BMP NUMBER: PC081

Marsh Hawk Course Holes 1-18

**ENVIRONMENTAL DIVISION REVIEW COMMENTS
FORD'S COLONY LOT 103 SECTION 10 (109 HOLLINWELL)
DIVISION PLAN NO. E&S - 08 - 08**

DESIGNED: N/A DATE: 08/12/05
CHECKED: SAR SCALE: 1"=10'
FILE MGR./DRAWN: JCZ CADD FILE NAME: LOT-103
PROJECT NUMBER: 2005096-000.00 DWG. FILE NO.: 16319AW
DRAWING NUMBER: C-1

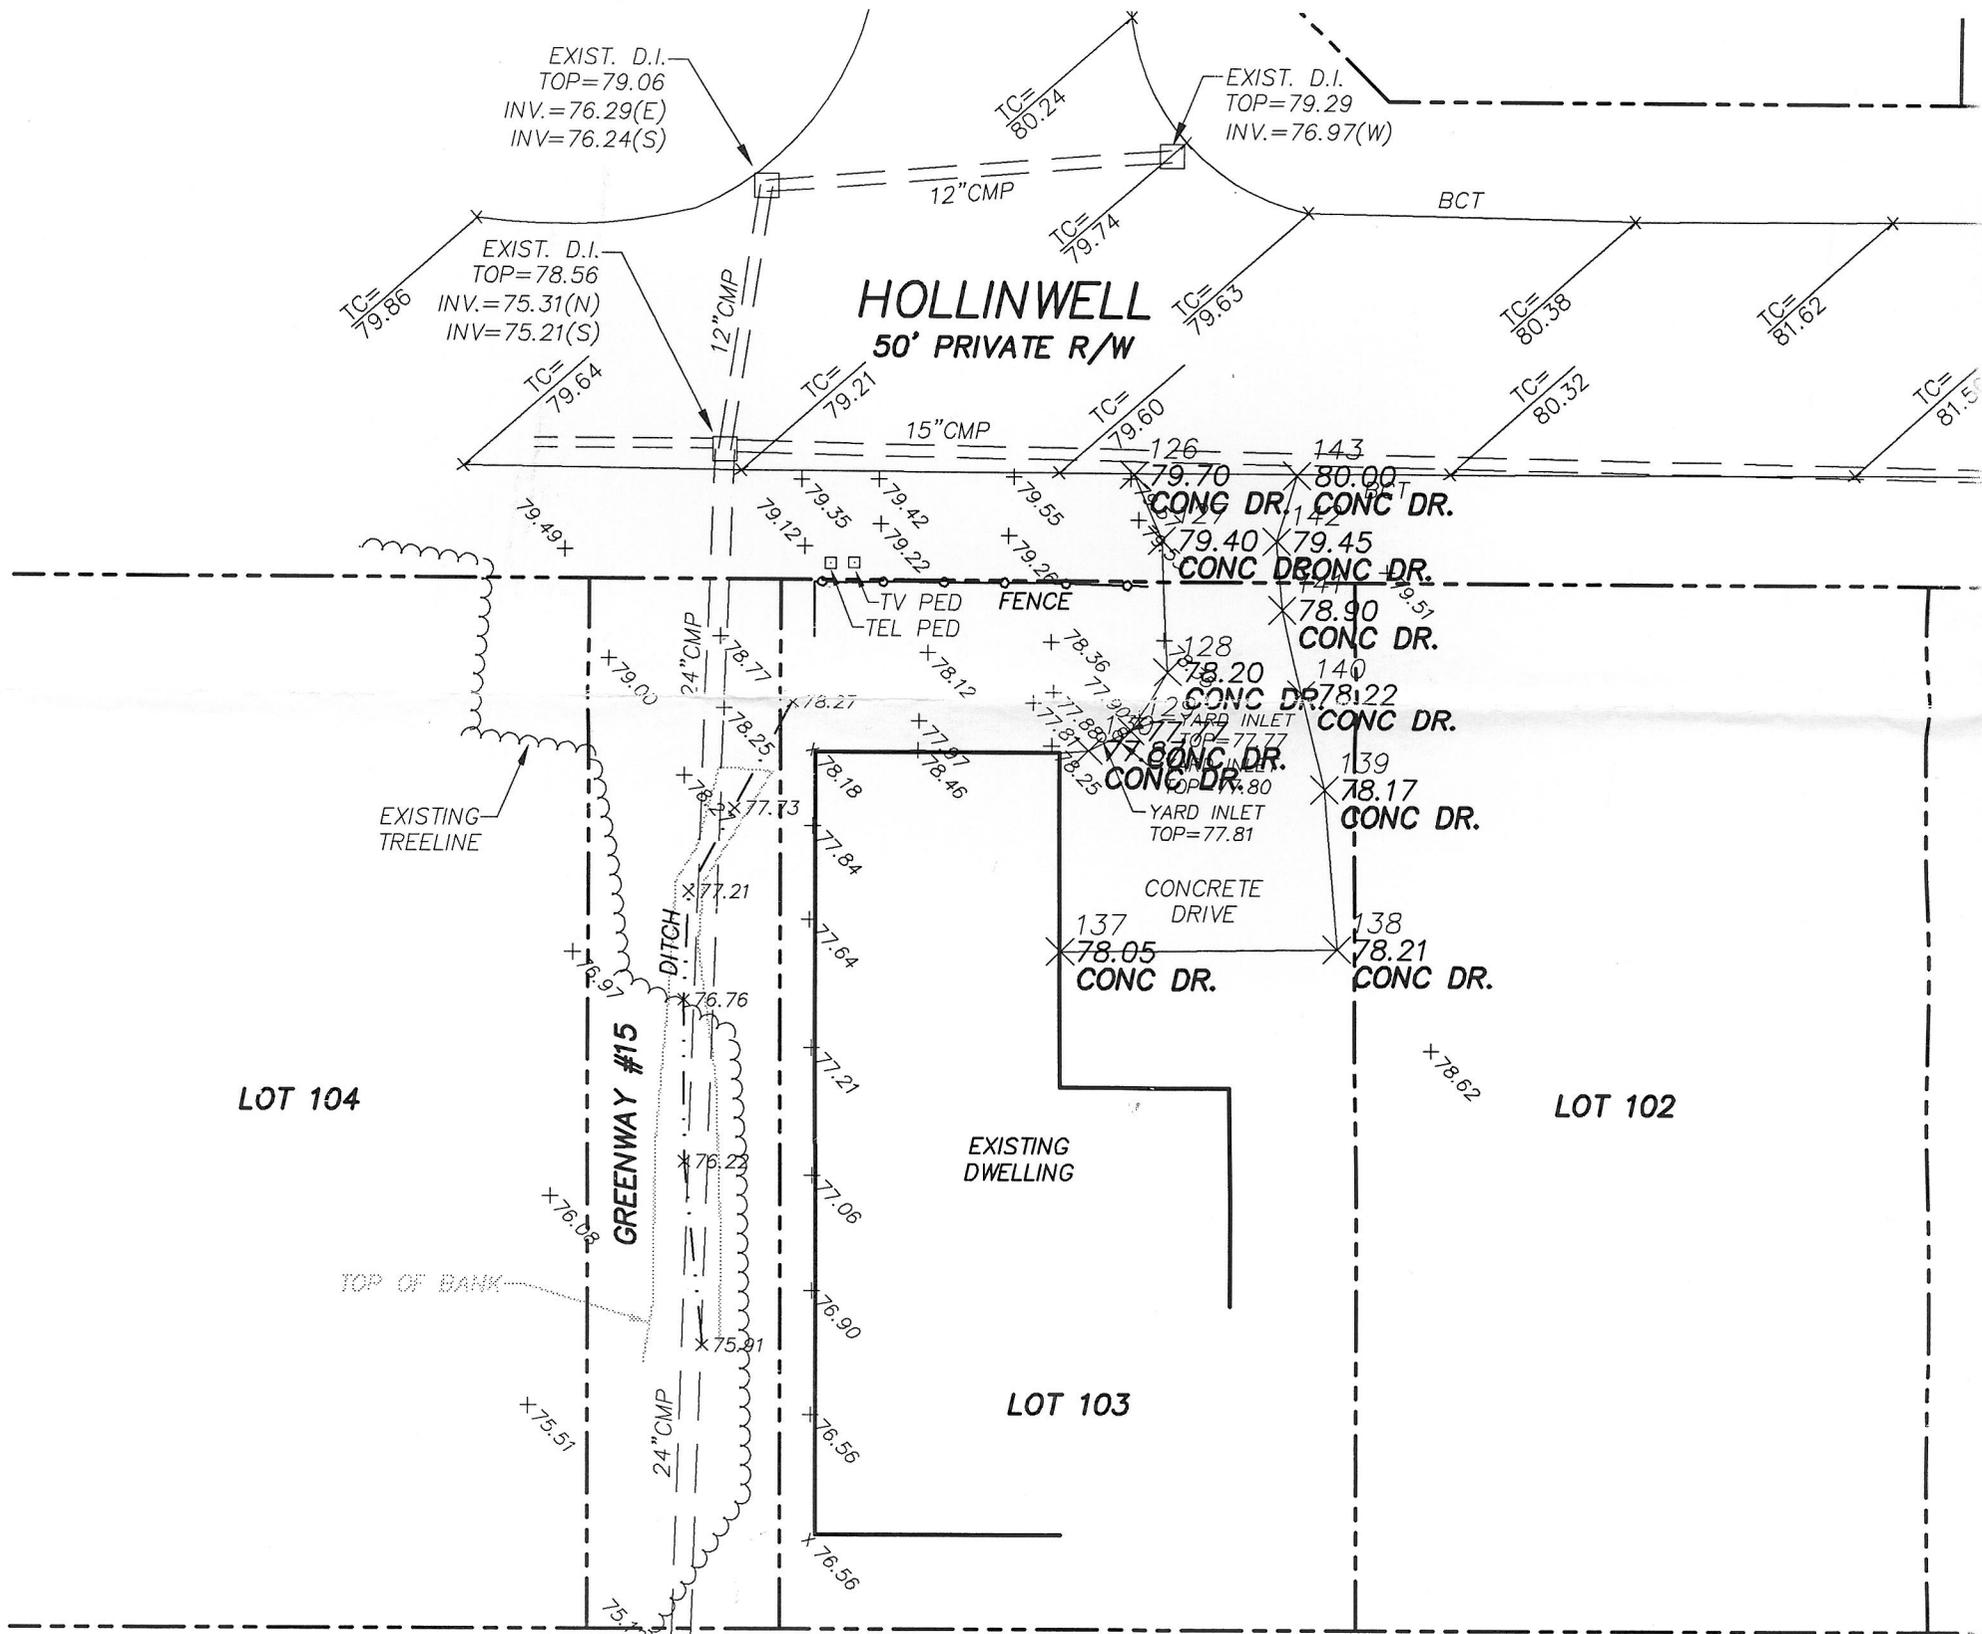
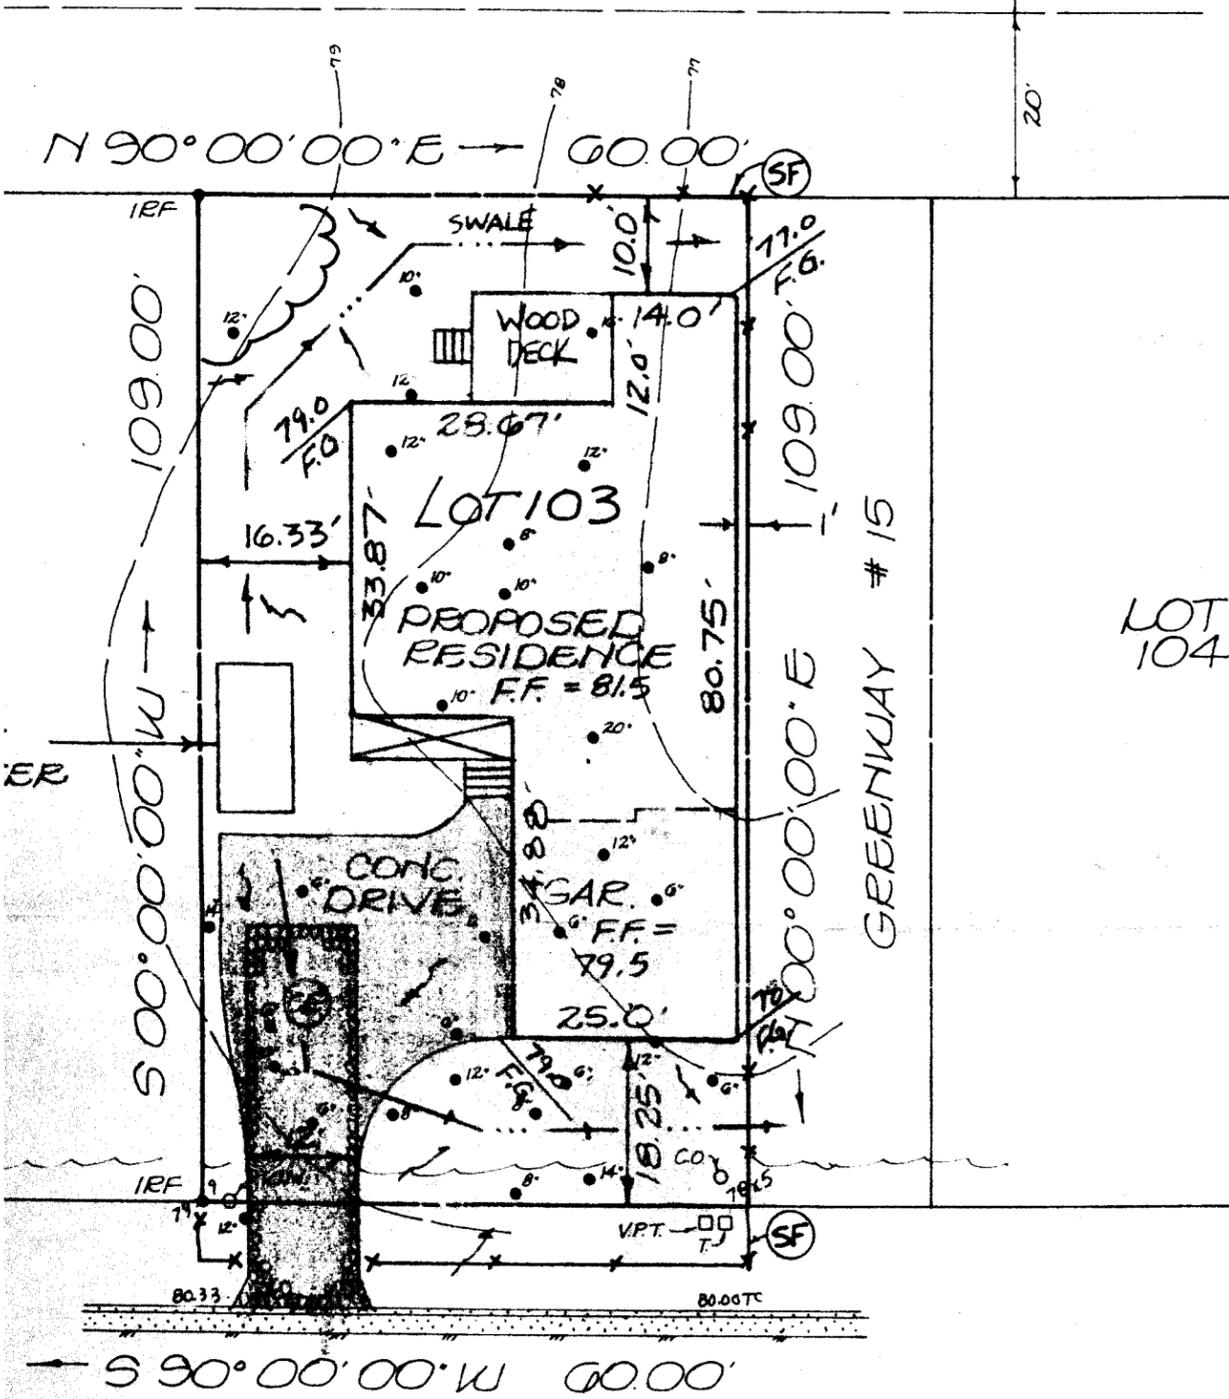
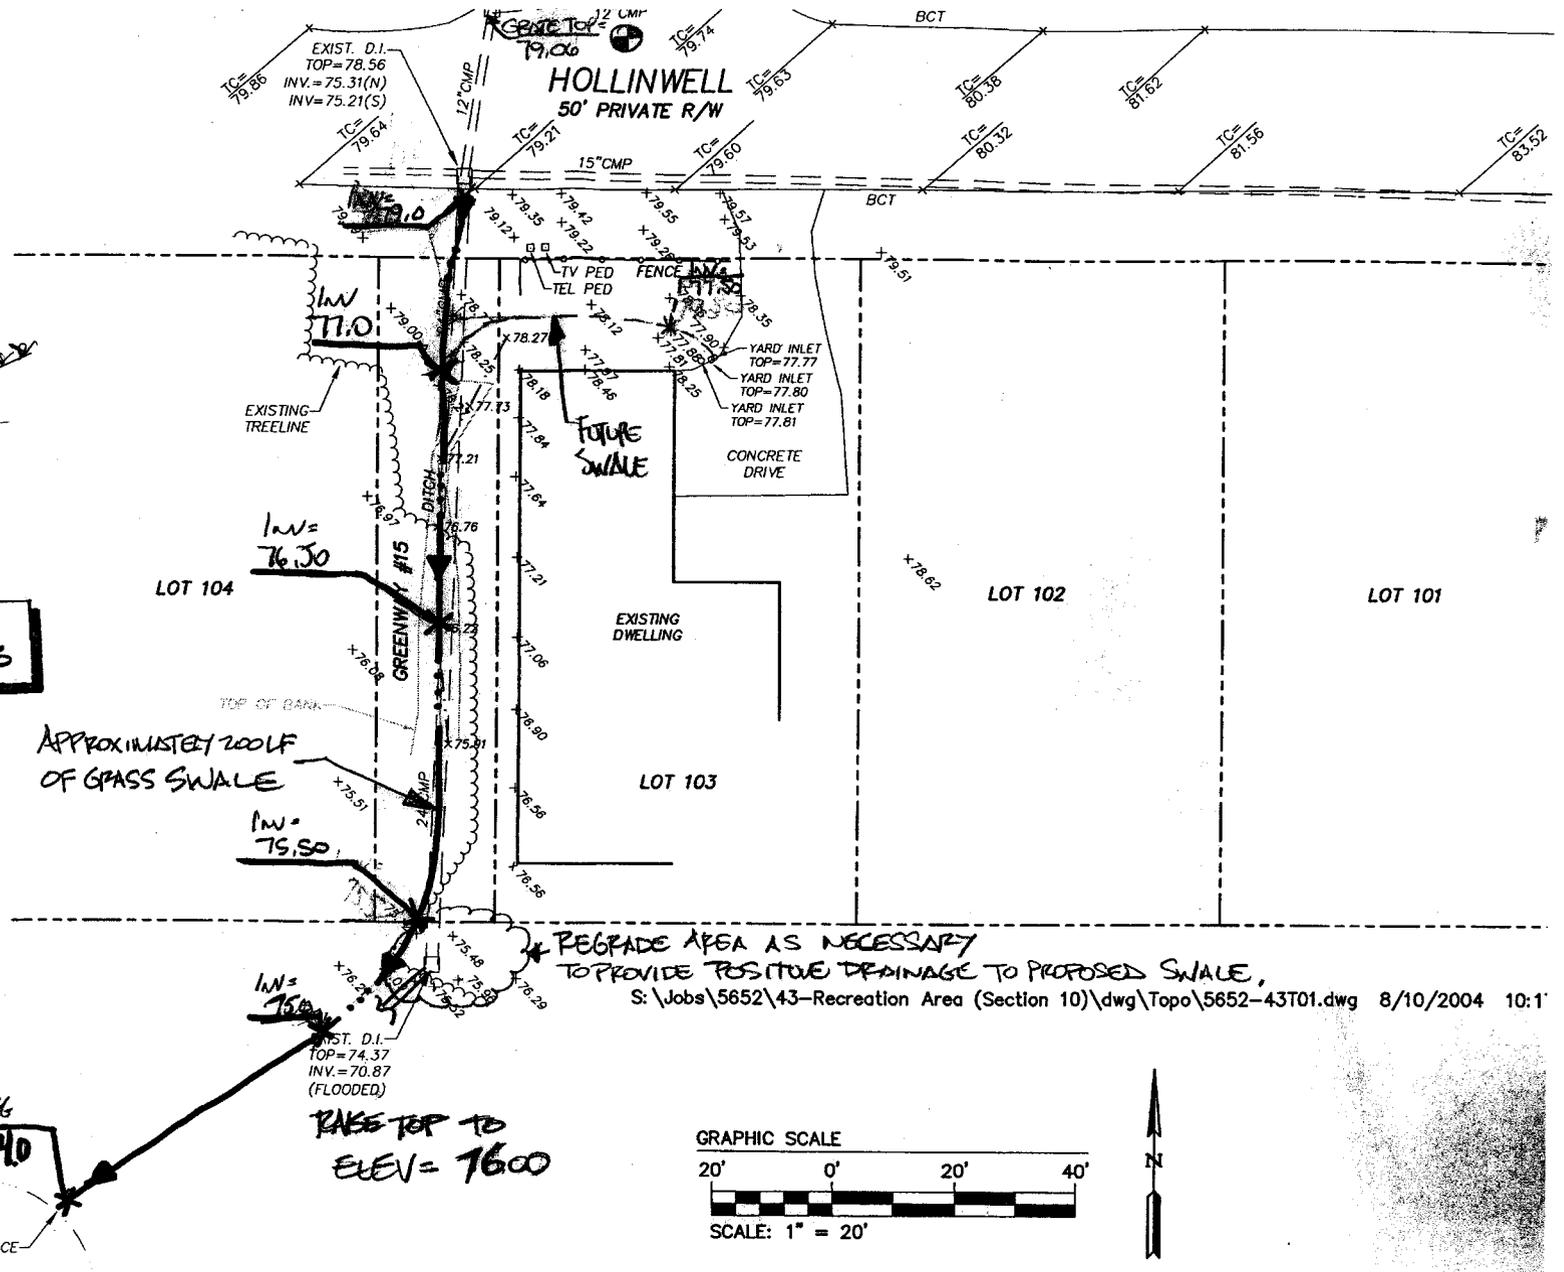
1. It does not appear that a Land-Disturbing Permit is required for the project.
2. It appears that grading is proposed beyond the property lines of Lot 103 (109 Hollinwell) into areas designated as "Greenways". Evidence of permission from the Greenway owner is required before our Division can approve the drainage improvement plan.
3. Label the area to the east of Lot 103 (109 Hollinwell). Based on County GIS information it appears that this is Lot 107. Also, based on County GIS information, the lot to the west is Lot 115, not Lot 104.
4. Many of the construction notes in the upper-right hand corner of the plan sheet appear to not be needed for this project.
5. The note that labels the greenway to the south of the lot cannot be read. It is covered up by erosion and sediment control Note # 20 and # 21.

6. Provide a brief sequence of construction which includes when stabilization is to occur.
7. The plan sheet shows a detail for a rock check dam erosion and sediment control measure; however, there is none shown on the plan view.

8. Based on County GIS, the potential exists for about ½ acre of upslope drainage area to be conveyed to the proposed inlet. Provide inlet and storm drainage computations to show that triple 8-inch drain pipes have adequate capacity to handle upslope and onsite flows for the 10-year design event. Also, ensure that depth of flow at the inlet does not impact the home (109 Hollinwell) or upslope properties. (Note: Refer to Item # 2.6, # 2.8, # 2.9, # 2.12 and entire Section 4.0 of the *James City County Environmental Division, Stormwater Conveyance Drainage Systems, General Design and Construction Guidelines.*)
9. Provide additional information on the type of HDPE pipe to be used for the project (ie. AASHTO M252, etc.). Provide a bedding details for drain pipe installation or, alternatively, provide notes referencing installation in accordance with ASTM D2321 or VDOT PB-1.

10. Provide a detail for the cleanout structures as proposed. Also, there appears to be a cleanout missing of the easternmost 8-inch pipe at the first bend from the inlet.
11. For the lot owner's benefit, provide a brief maintenance plan for system cleaning and operation, including any special long-term maintenance requirements for the Scourstop © product.
